PUR-1695 ADDENDUM NO. 1 INVITATION TO BID

ARFF BUILDING DEMOLITION; AOA FENCE/ACCESS GATE REALIGNMENT

DATE: Friday, July 5, 2024 BIDS DUE: Wednesday, July 10, 2024

FILE NAME: H:\OTHER\Wash-Co-Airport\24-32110 Fire Station Demo SSGP\Engineering\Drawings\01-Standard Grading Plan\ES100.dwg LAYOUT NAME: ES100 USER: dmoser PLOTTED: Tuesday, July 02, 2024 - 9:32am

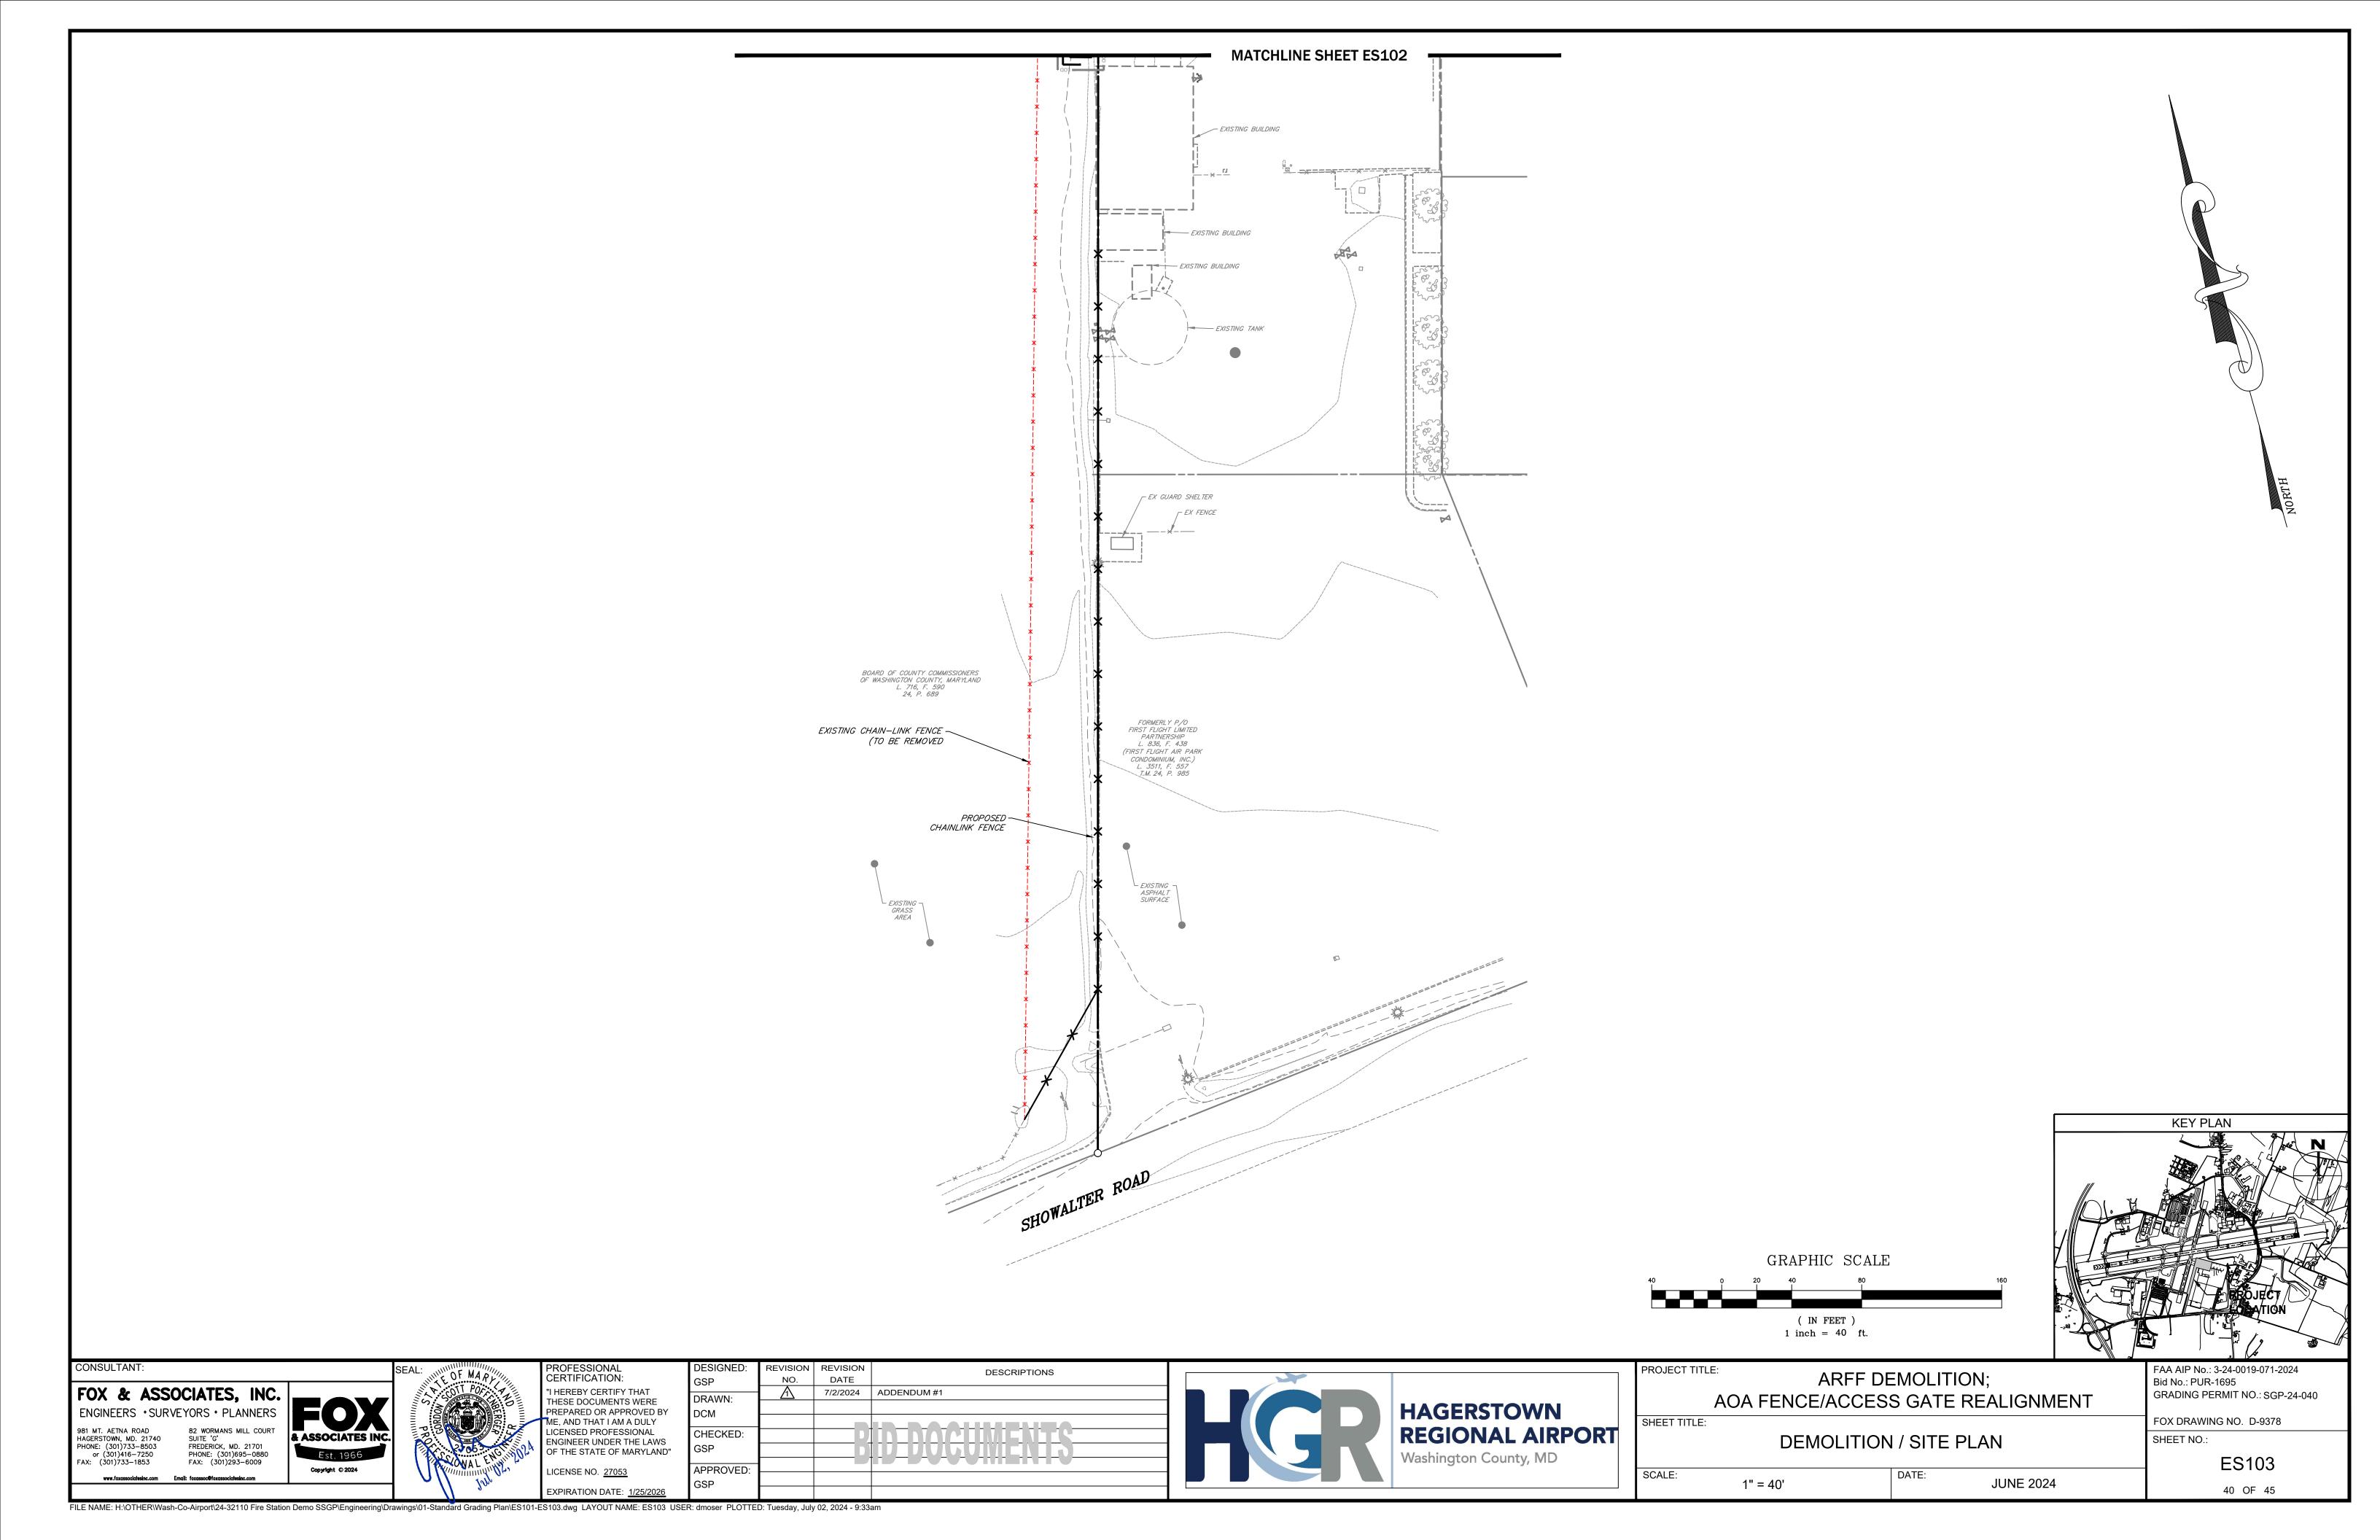
ITEM NO. 4: Inquiry: Do you have existing grading plans or information on existing grades in the area of the new 160' gate? The new gate has a very small tolerance for slope, the concrete foundation / track must be installed with a maximum slope of 1.5" per every 10' of track. It is our understanding that the existing asphalt in the area of the new gate location contains slopes greater than this allowance. This could require significant changes to existing grades and significant amounts of new paving to prevent to provide gradual transitions between existing pavement and the proposed gate track.

<u>Response</u>: We have included the site-specific grading plans that were utilized to obtain the grading permit. Please INSERT Sheets 37-41 which are provided by Fox & Associates, Inc. There will not be significant changes of grades needed in the proposed area of the 160' gate opening, however, there may be some minor transitional milling and/or paving required to tie portions of the proposed concrete gate foundation and existing grades together. This was called out on Note 5. of Sheet CF202 and is incidental to the installation of the gate.

E0.1 **42** OF 45

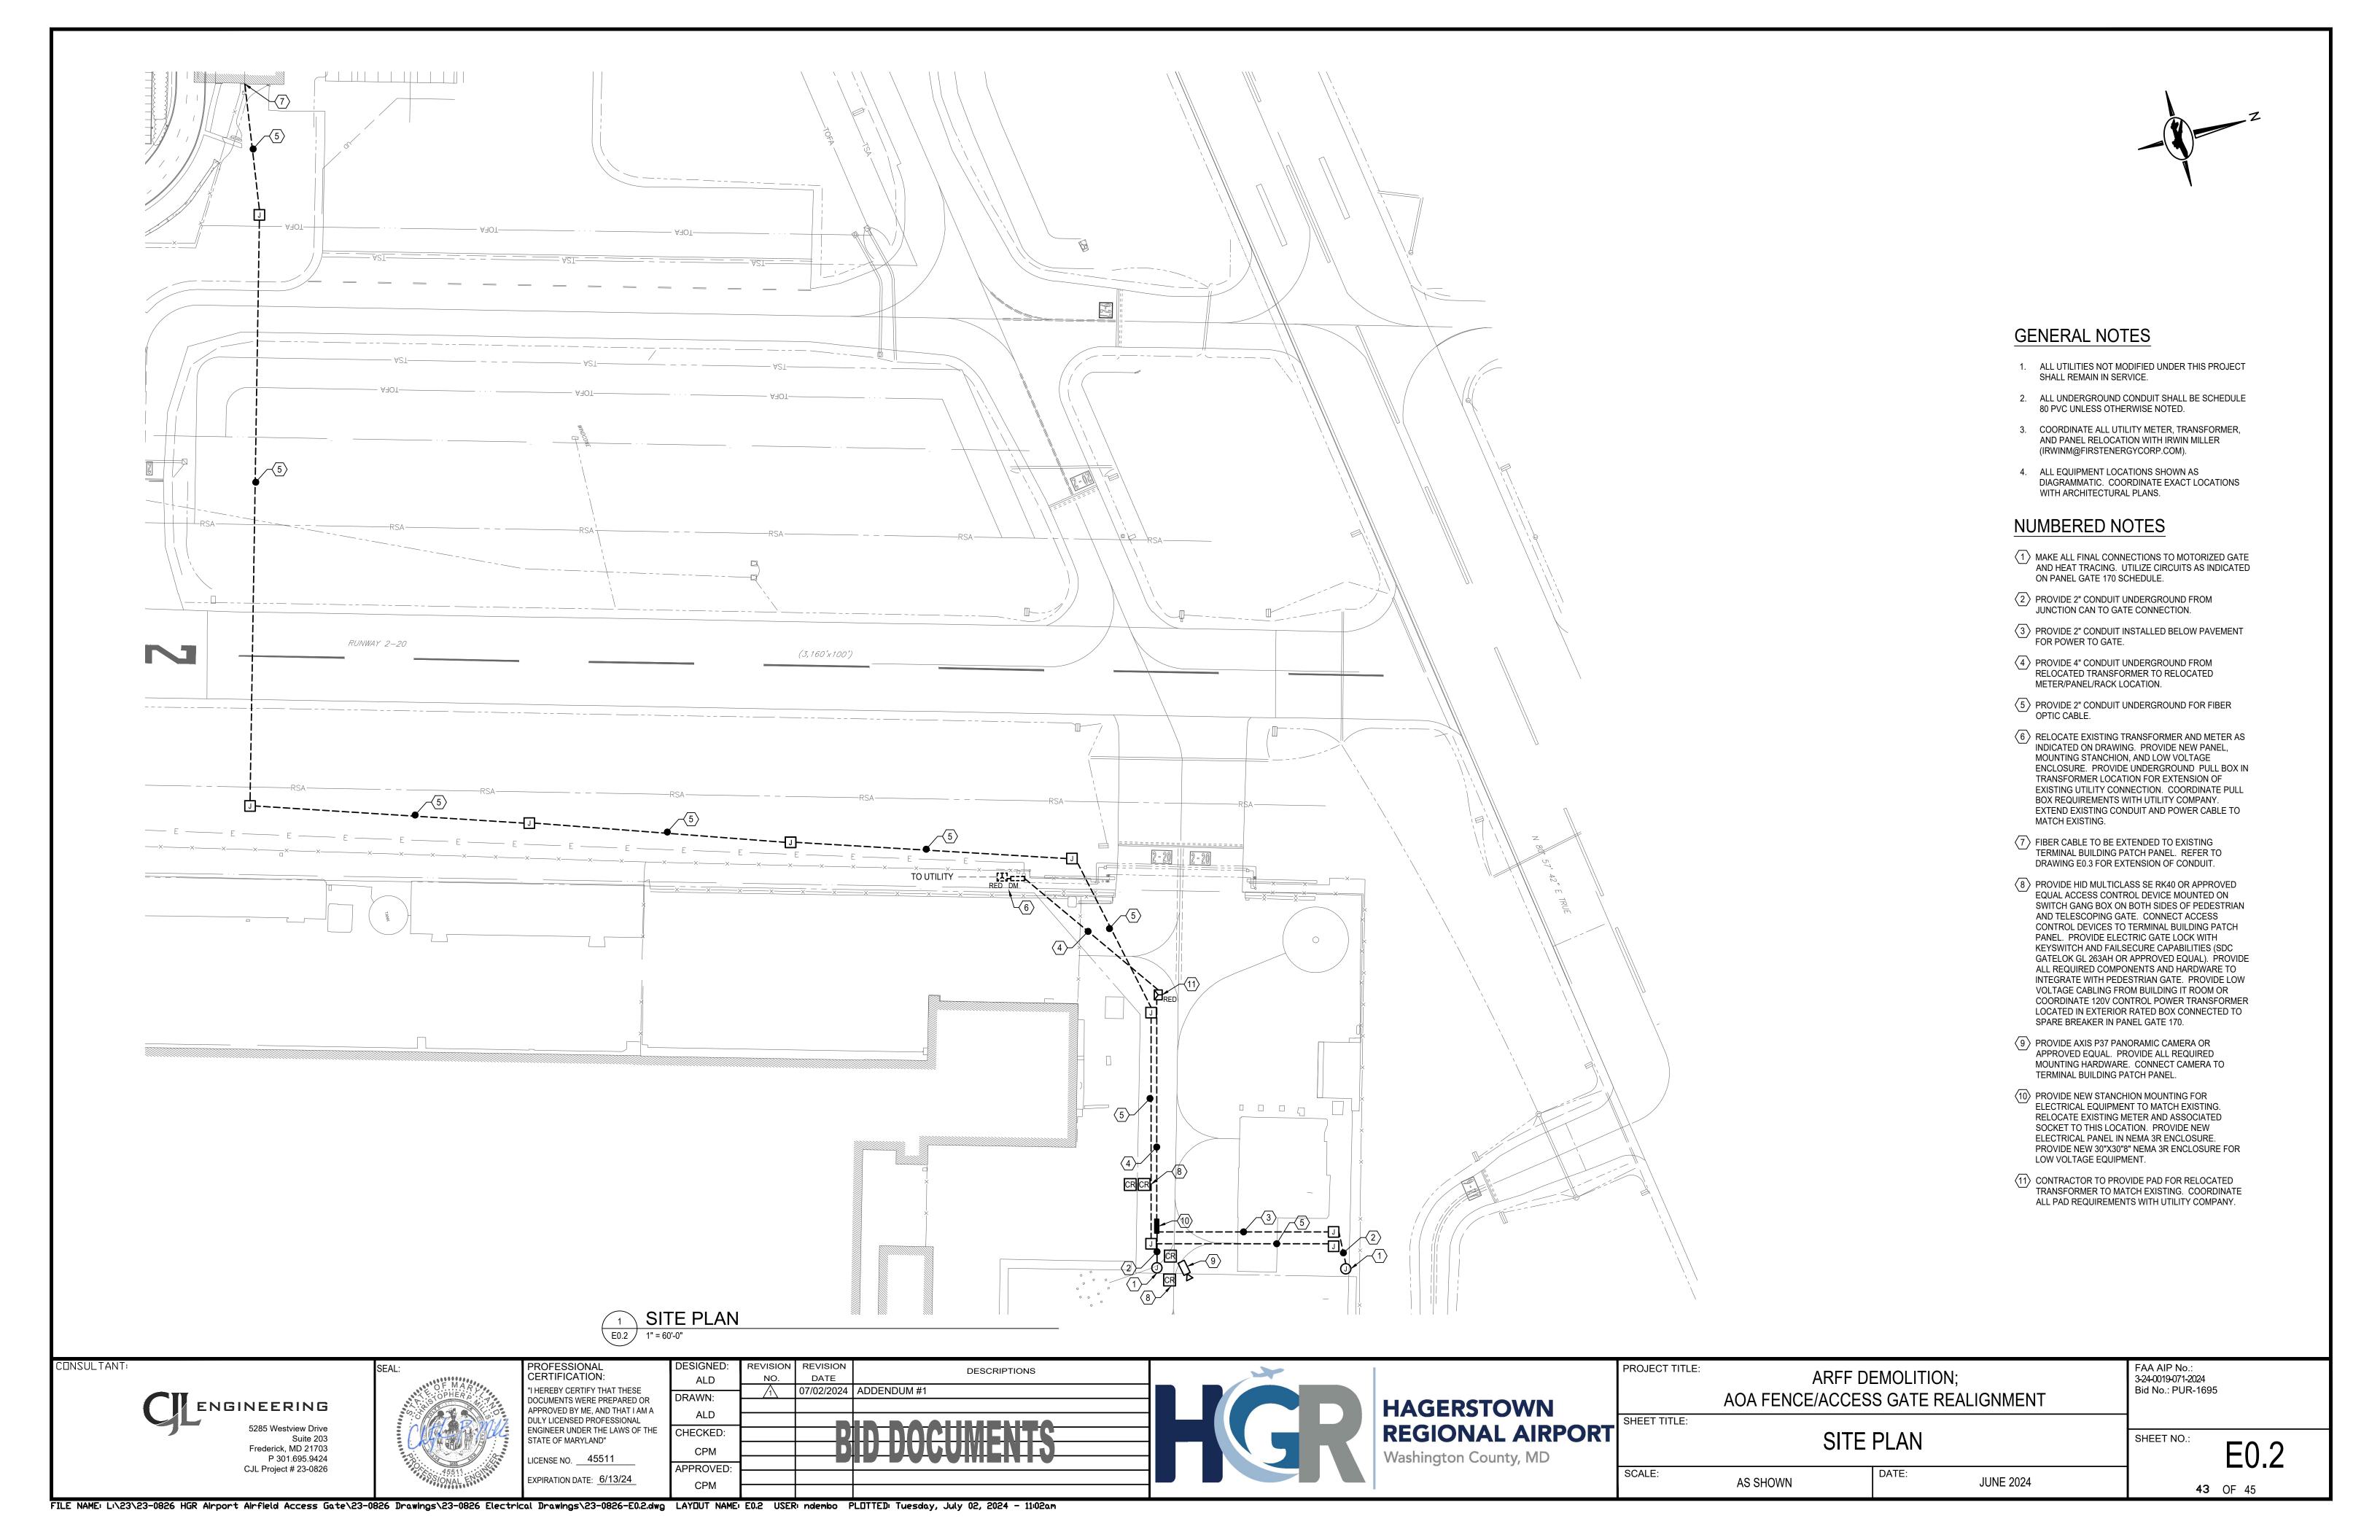
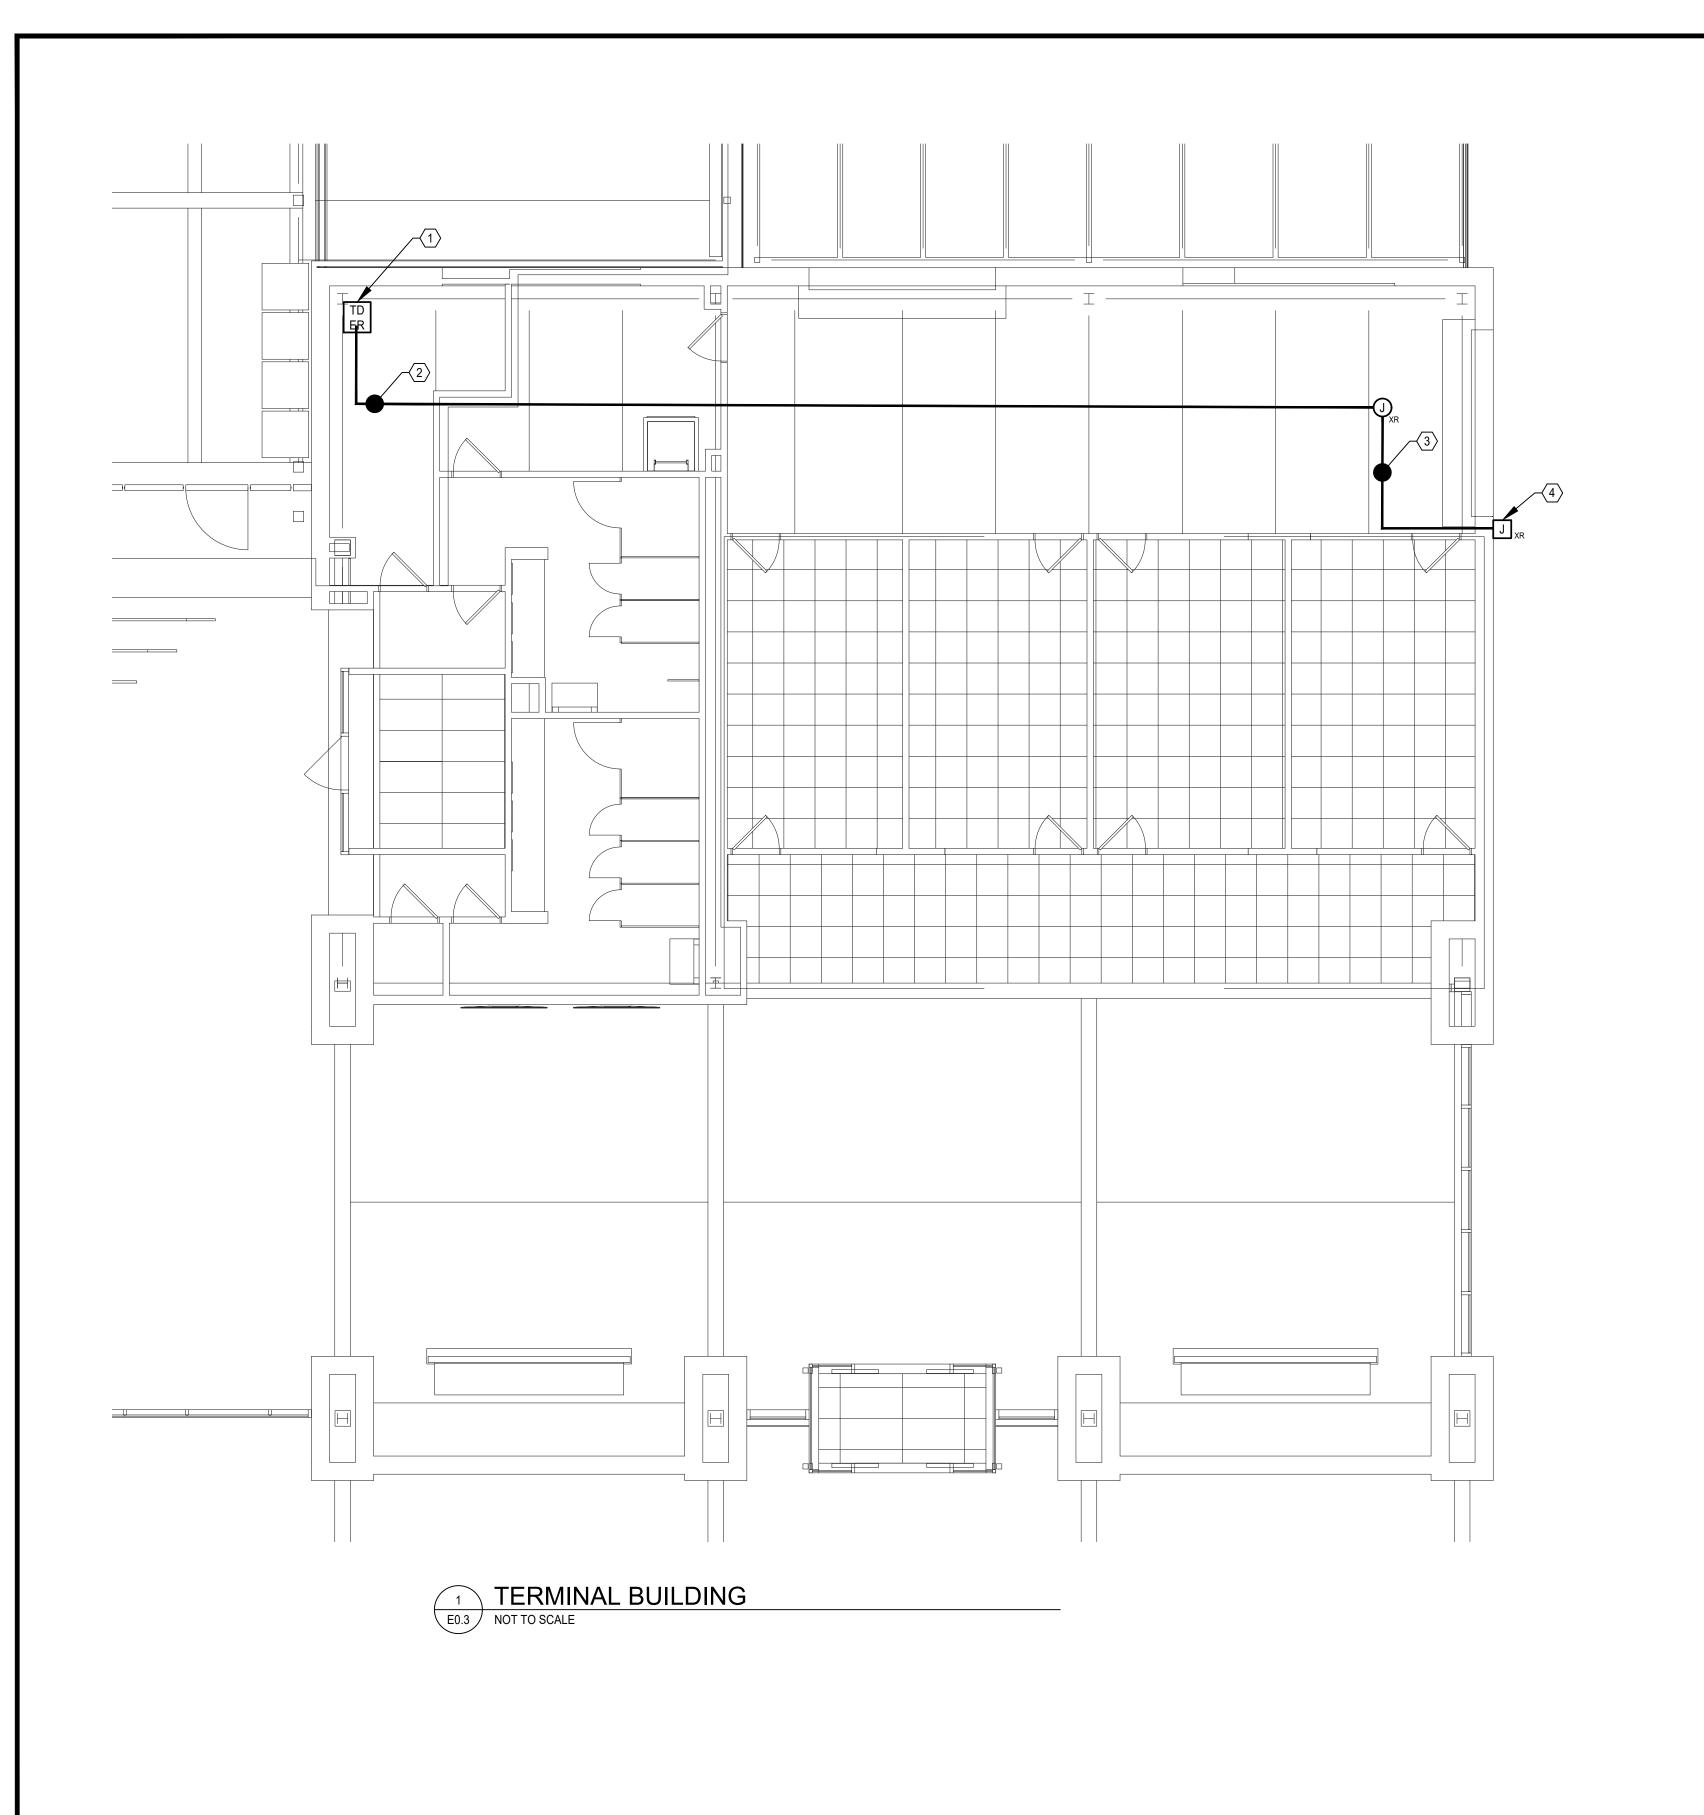
ITEM NO. 2: <u>Inquiry</u>: We see the summary describing the ACS and VMS portion of the scope but it does not include the drawing that specify what/where devices go. Can you guide me where to obtain these documents.

<u>Response</u>: We have included the Electrical/Utility drawings provided by CJL Engineering. Please INSERT Sheets 37 to 45 to the end of the drawing set.
